Date: November 30, 2023
To: All Vendors
Subject: Addendum #2

**REFERENCE: B014-24 Re-Bid BPUB Downtown Wastewater Improvements-ARPA
Project 1**

Project:	Brownsville PUB – Downtown Wastewater Improvements ARPA Project 1 BPUB Bid No. B014-24	Addendum Date:	November 30, 2023
From:	Javier A. Esquivel, PE	Project No.:	BPUB2200025.01

ADDENDUM No. 2

SHEET
CB01

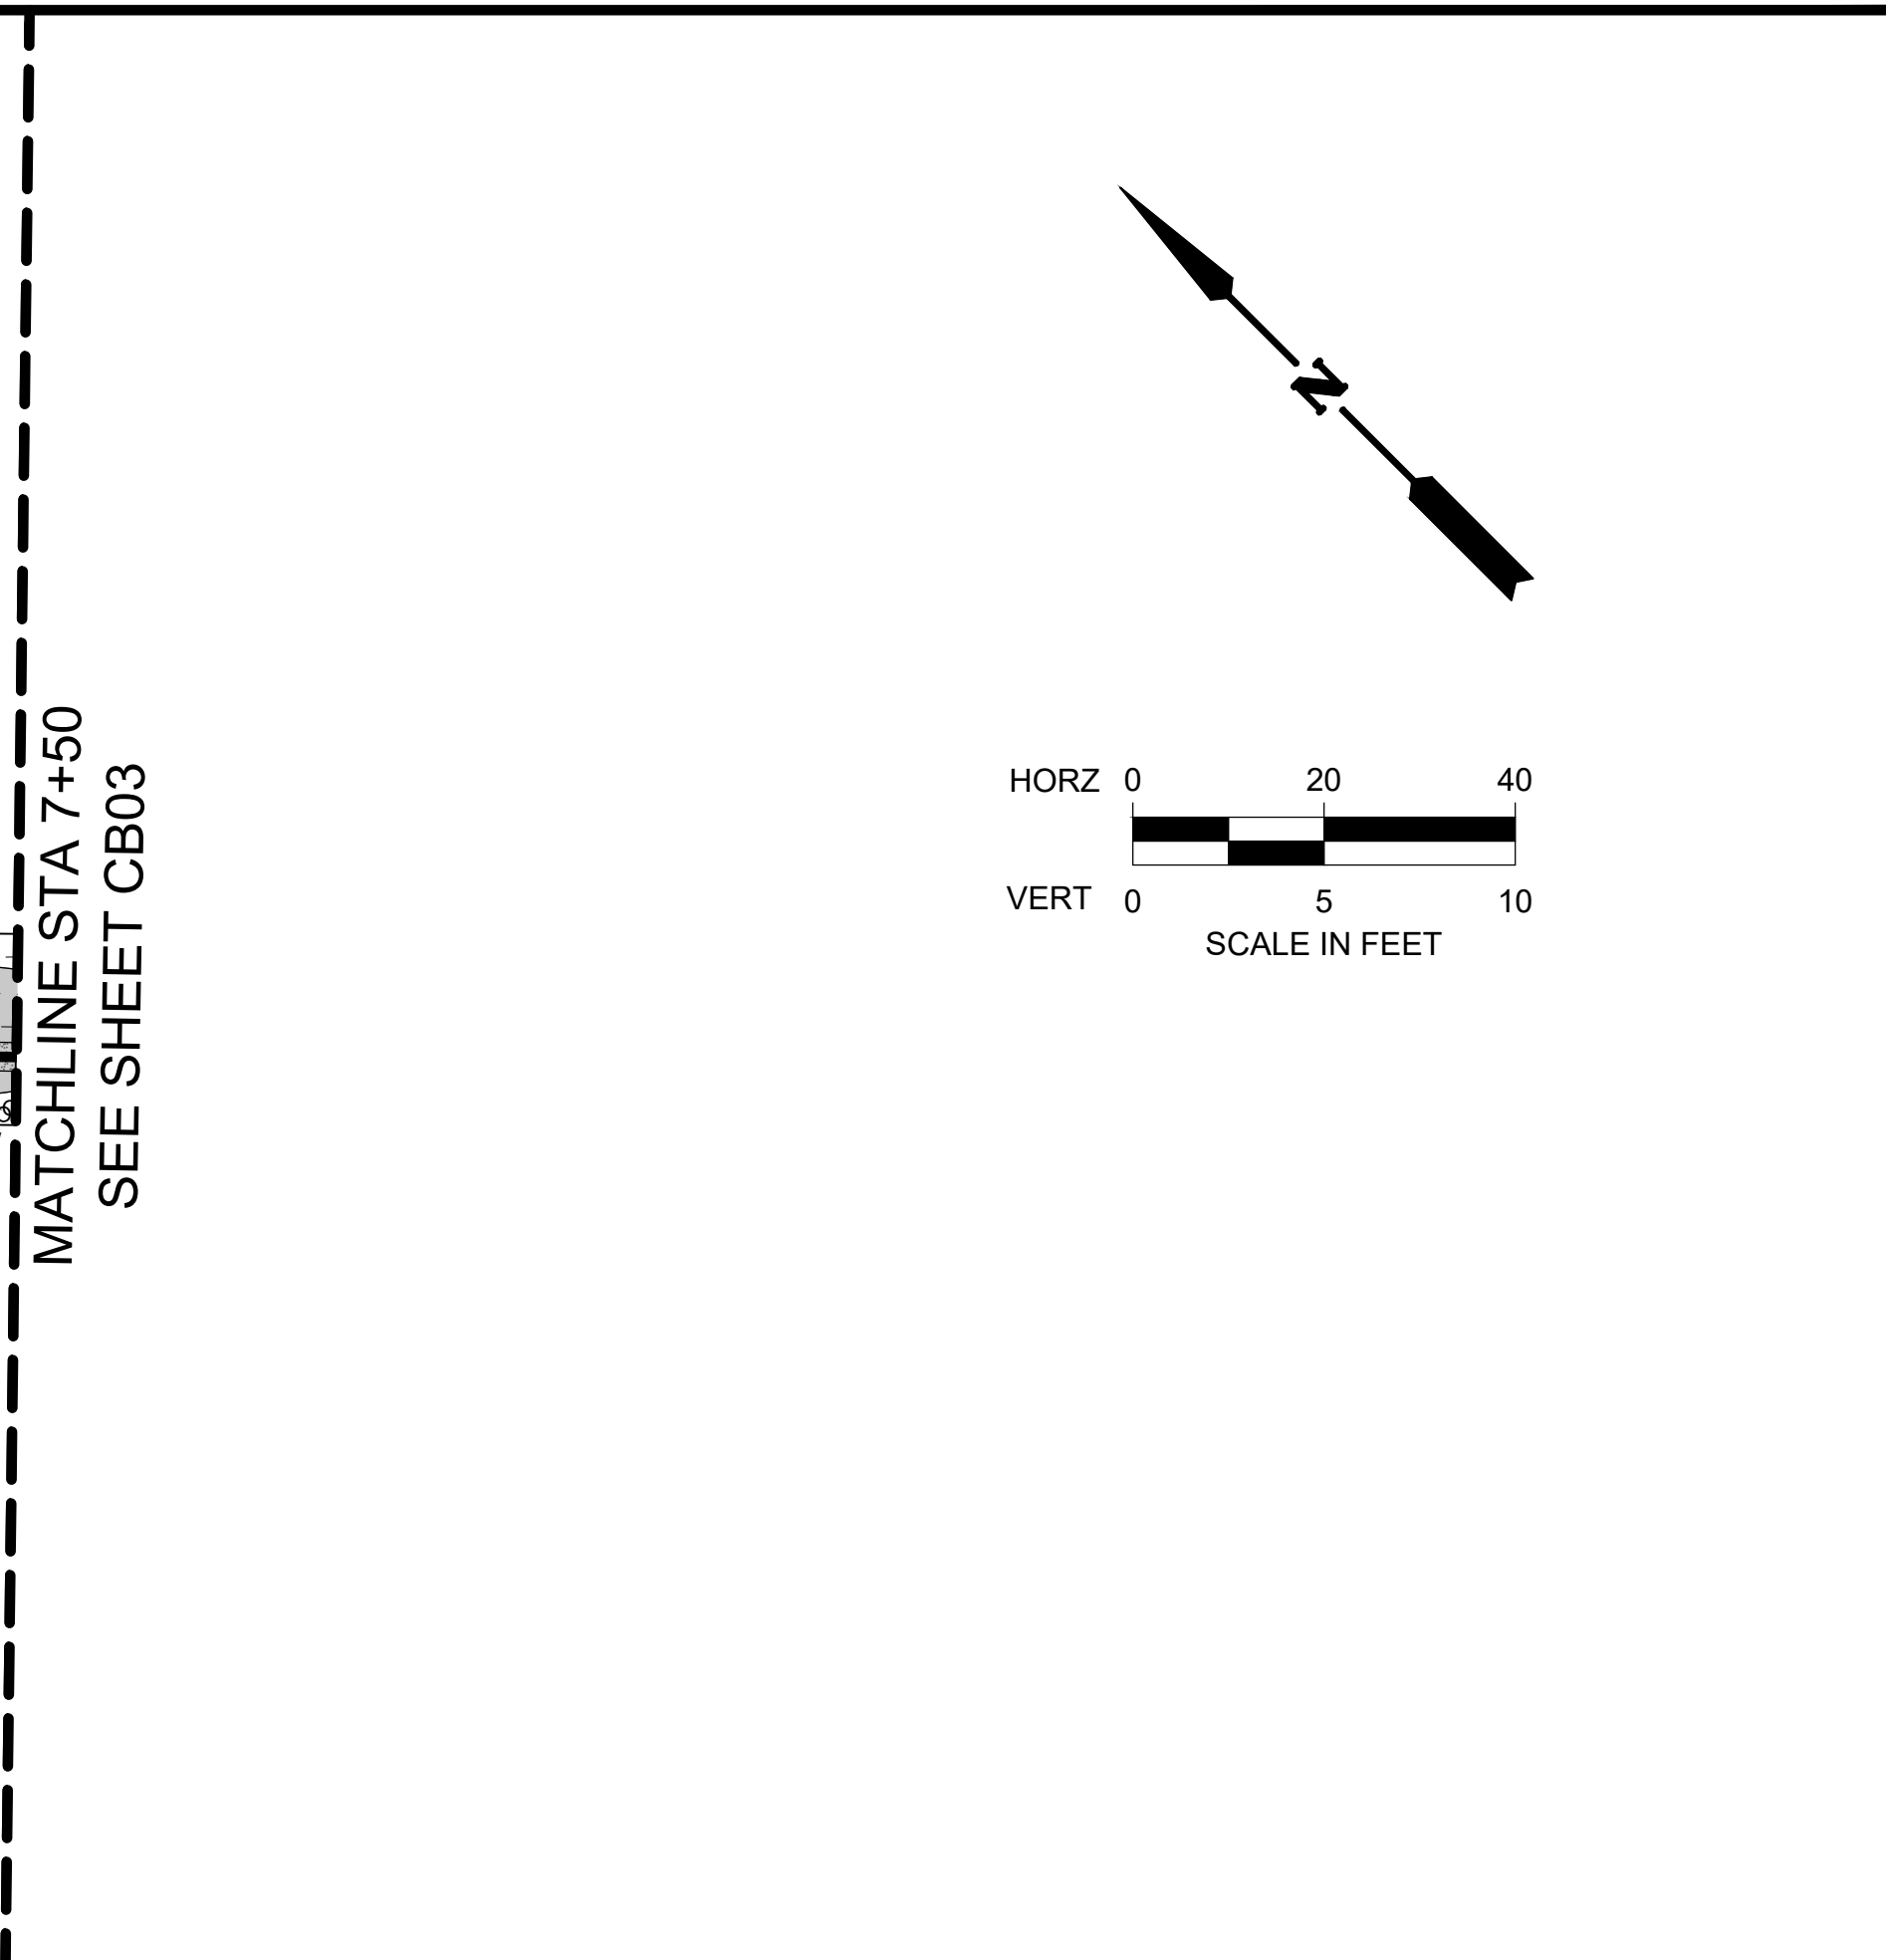
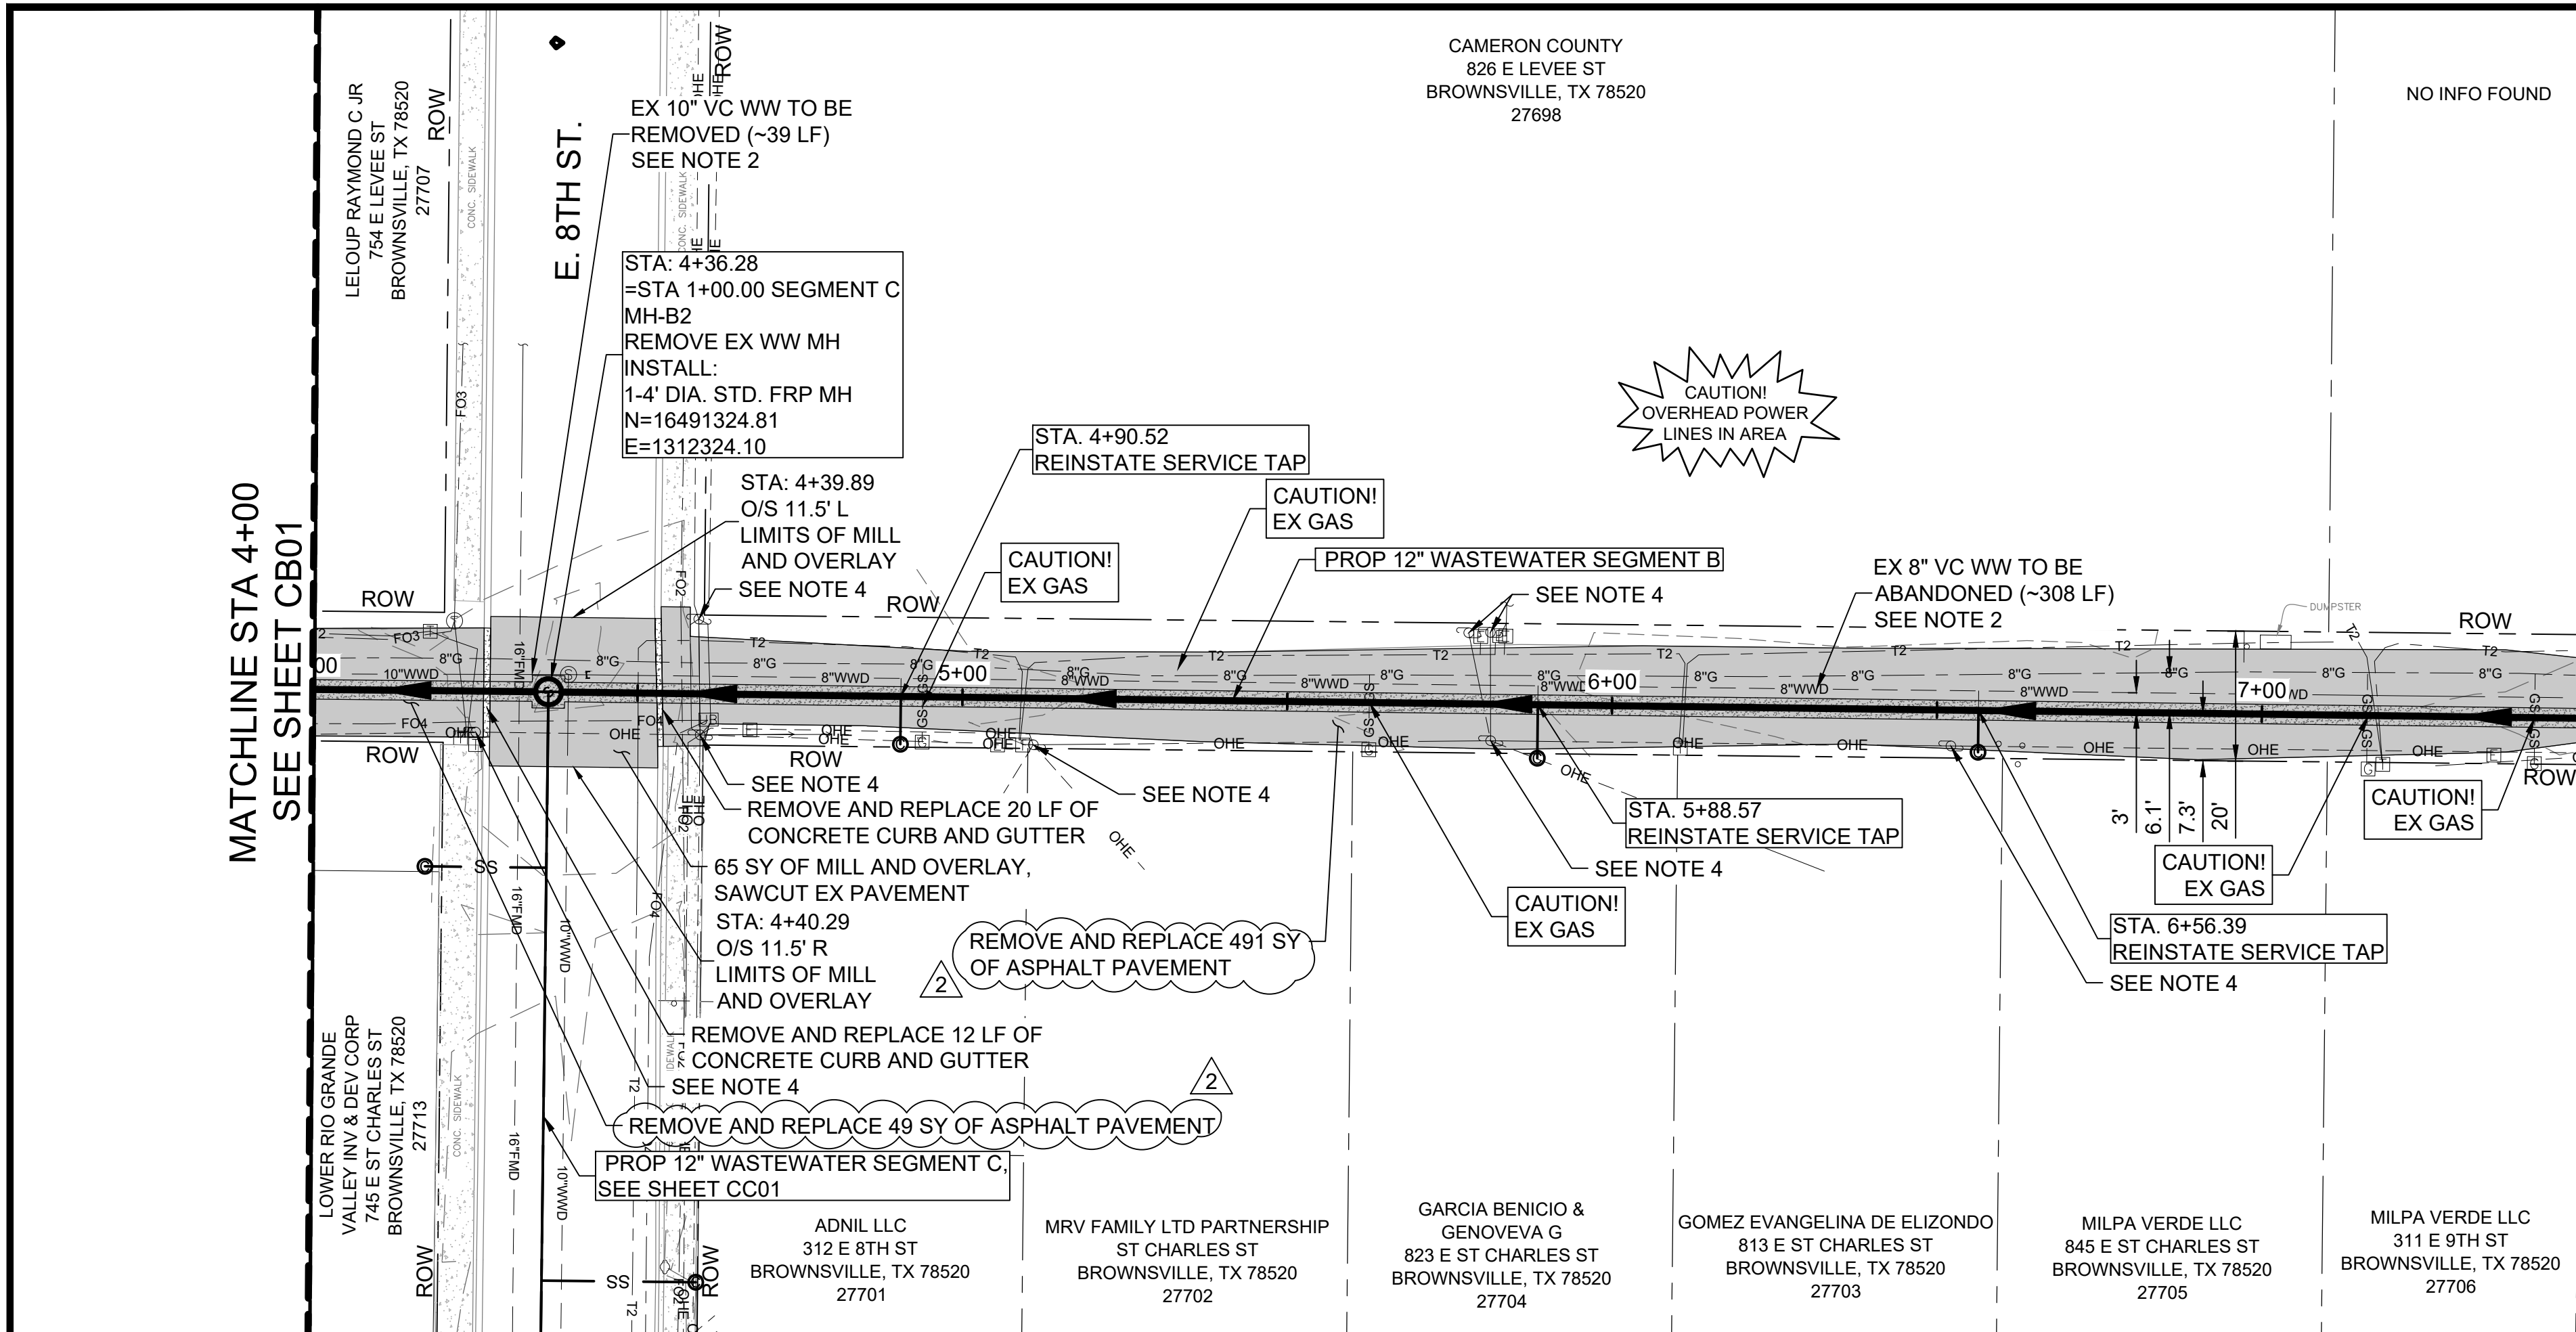
1. Revisions to Surface Restoration in the Alleys.
 - Segment A: Replace Mill and Overlay (2”) with full depth concrete asphalt pavement removal and replacement.
 - Segment B: Replace Mill and Overlay (2”) with full depth asphalt pavement removal and replacement.
 - Segment C: Replace Mill and Overlay (2”) with full depth asphalt pavement removal and replacement.

3. Plan Sheets: The following plan sheets were modified to update surface restorations CA02, CA03, CA04, CA05, CA06, CA07, CB01, CB02, CB03, CC02, CC03, CC04, and CC05.
